L. William Pearce  
Vice President724-682-5234  
Fax: 724-643-8069February 22, 2005  
L-05-022U. S. Nuclear Regulatory Commission  
Attention: Document Control Desk  
Washington, DC 20555-0001**Subject: Beaver Valley Power Station, Unit No. 1 and No. 2**  
**BV-1 Docket No. 50-334, License No. DPR-66**  
**BV-2 Docket No. 50-412, License No. NPF-73**  
**License Amendment Request Nos. 314 (Unit 1) and 187 (Unit 2)**

### Beaver Valley Power Station, Unit Nos. 1 and 2 License Amendment Request Nos. 314 and 187

Subject: Application for Amendment to the Radiation and Accident Monitoring Technical Specifications - Implementation of WCAP-15981, "Post Accident Monitoring Instrumentation Re-Definition for Westinghouse NSSS Plants"

TABLE 3.3-6

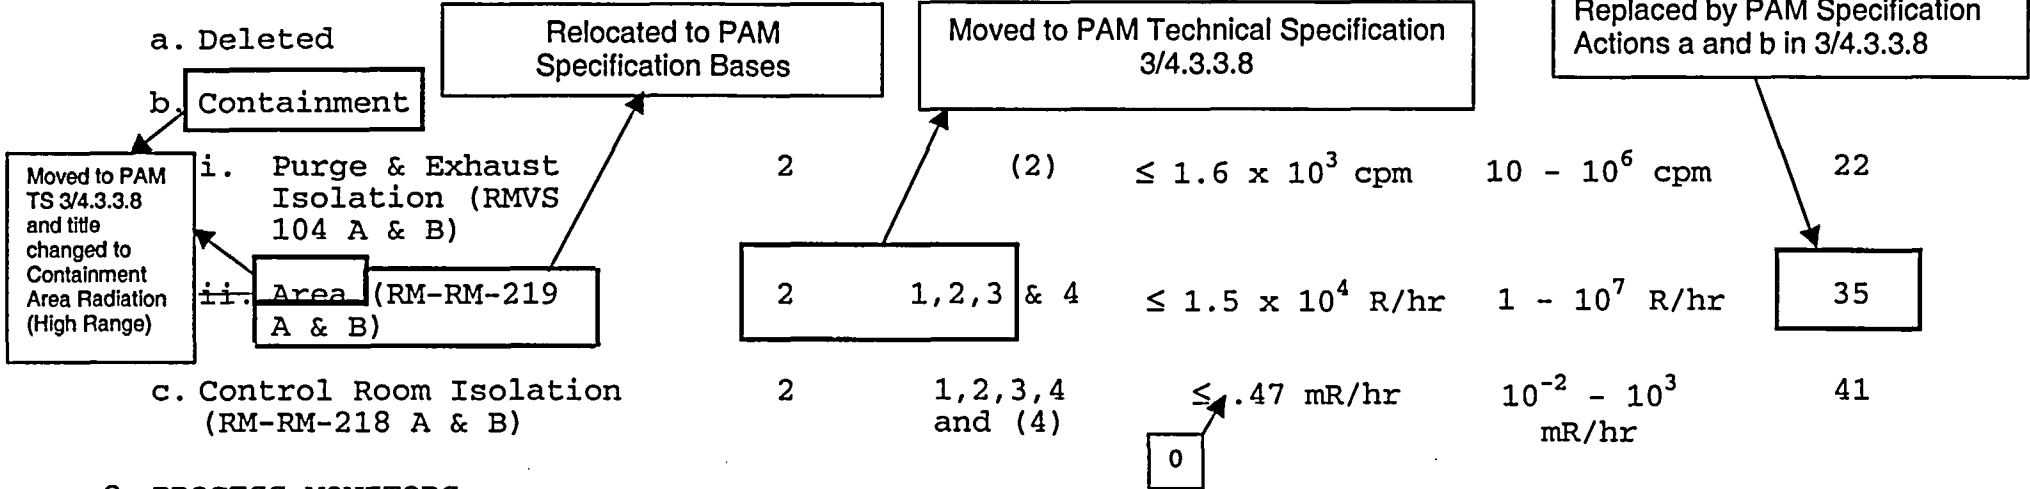
Reviewers Note: The markup on this page includes the changes associated with the relocation of the Containment Area Radiation Monitor Alarm Function to the LRM. The markups are not applicable to other Radiation Monitors in this Specification.

TABLE 3.3-11

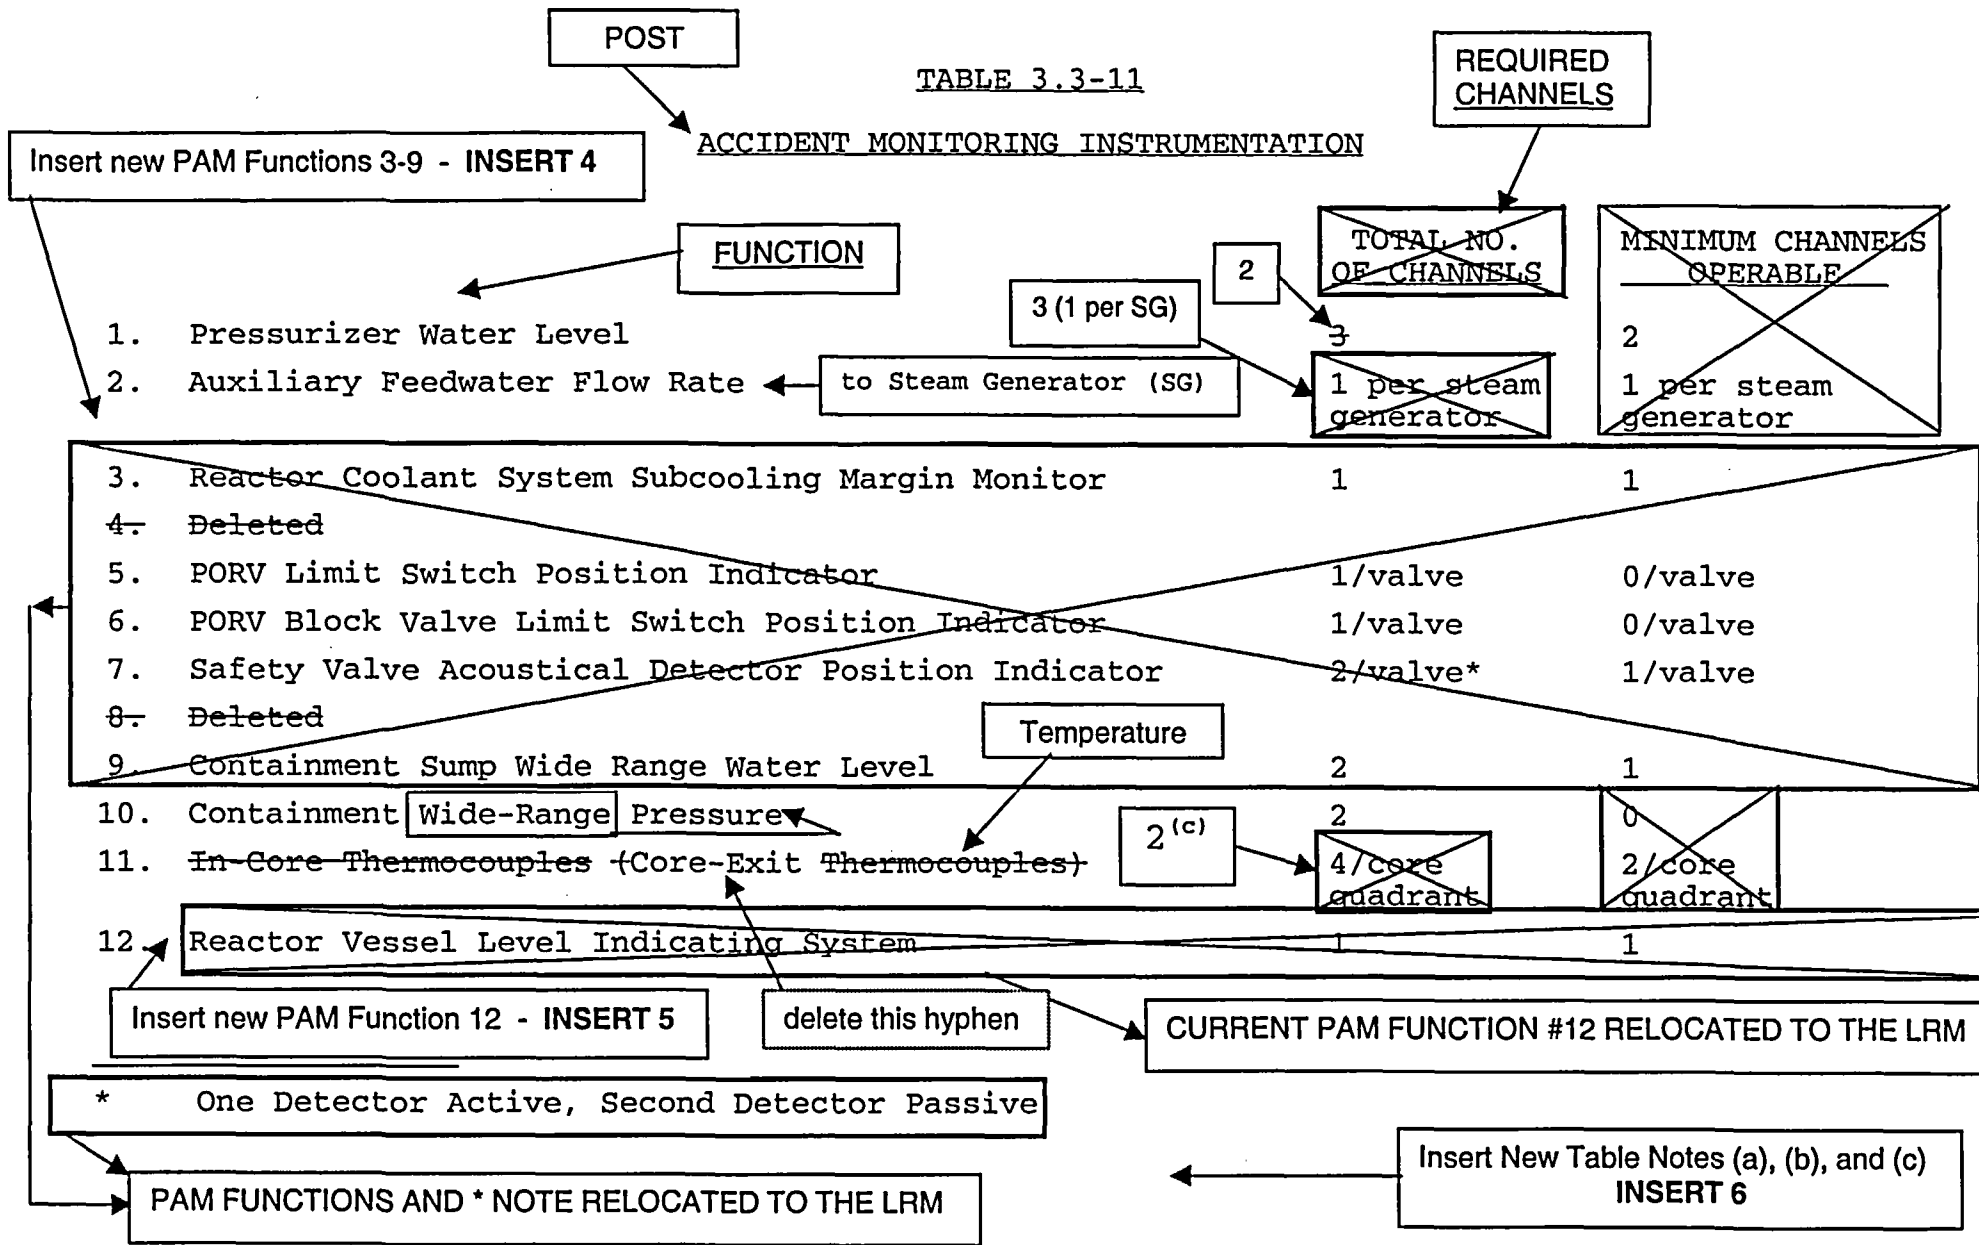
**Relocated to the LRM to support the relocation of those PAM Functions identified as relocated to the LRM.**
